Re Placement of Noise Source after Filtering

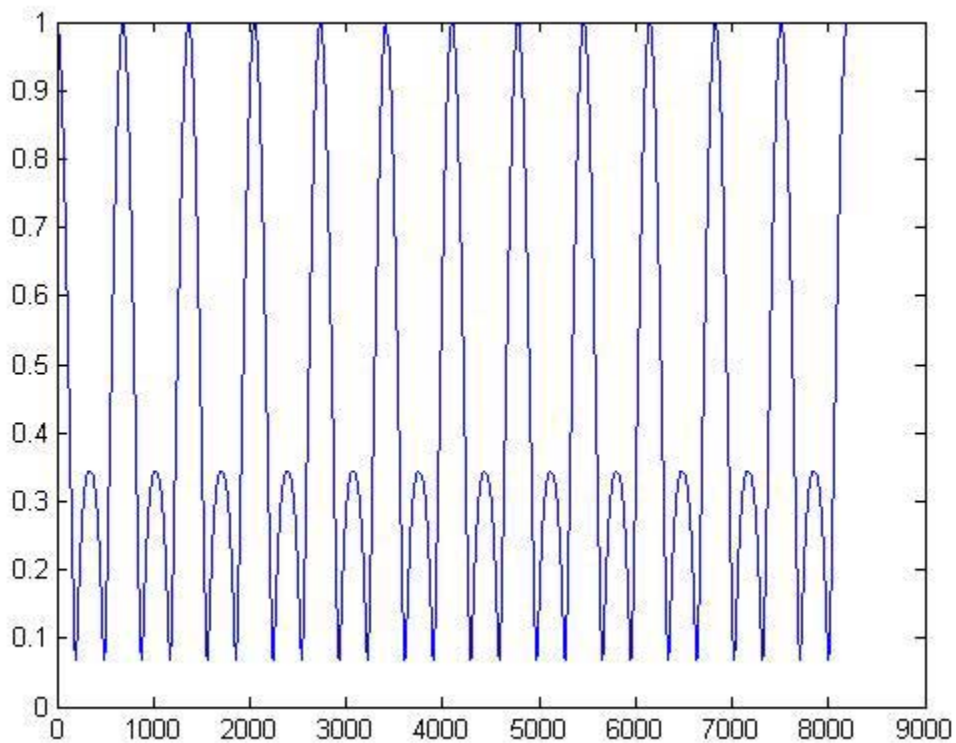
We recommend that the reference comprehensive stressed receiver test, illustrated in Fig. 68-10 be unchanged so that the Noise introduced also passes through the Pulse-shaping filter. Our recommendation is closer to the “real world” as we show below:

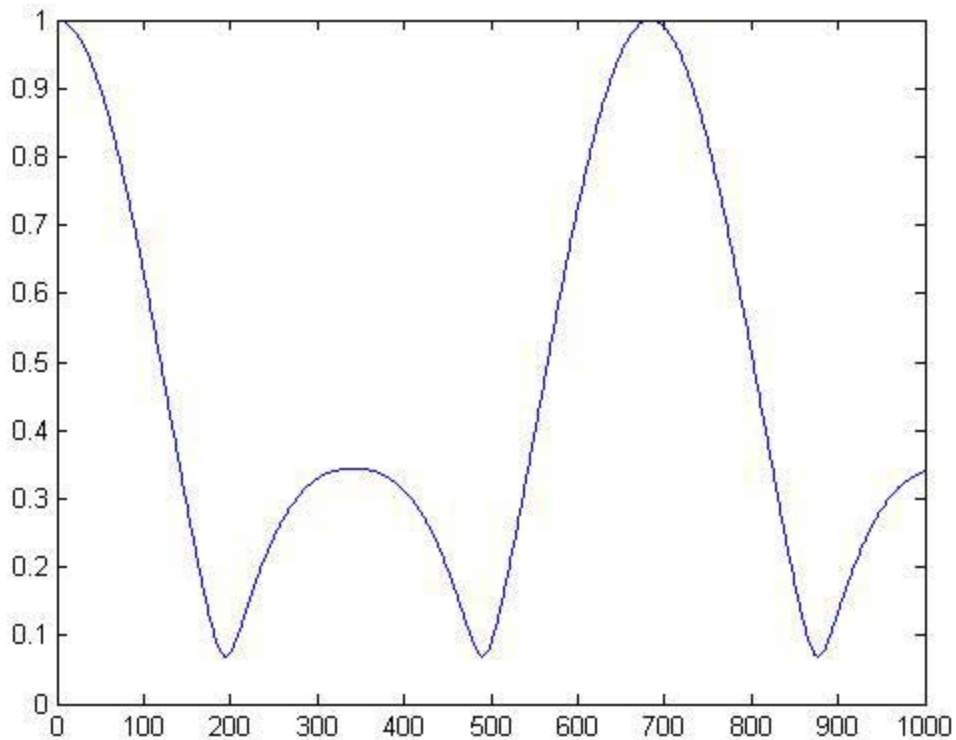
In order to see what the noise spectrum would look like if we were to adapt the proposed changes to D2.0 (as a response to comment #346), we ran white noise through the ISI generator, we ran the TWDP MATLAB® program and plotted the ISI frequency response with “plot(abs(Hx))”:

The horizontal scaling is that each bin corresponds to about 20.14 MHz so that the highest displayed frequency corresponds to 160 GHz!

If we concentrate upon the first 1000 bins (namely out to about 20 GHz) with the command, “plot(abs(Hx(1:1000)))”:

Were we to adopt the response to comment #346 to D2.0, we see a huge peak above the low frequency end at about bin 700. This would correspond to about 14 GHz. This is a result of the ISI model that uses a ΔT of 0.75 UI.

However, in the real world, chromatic and modal dispersion due to 300 meters of legacy multimode fiber would not permit the peaks at 14 GHz and multiples thereof to exist as shown.

Thus we recommend that the reference comprehensive stressed receiver test, illustrated in Fig. 68-10 be unchanged so that the Gaussian noise introduced also passes through the Pulse-shaping filter.
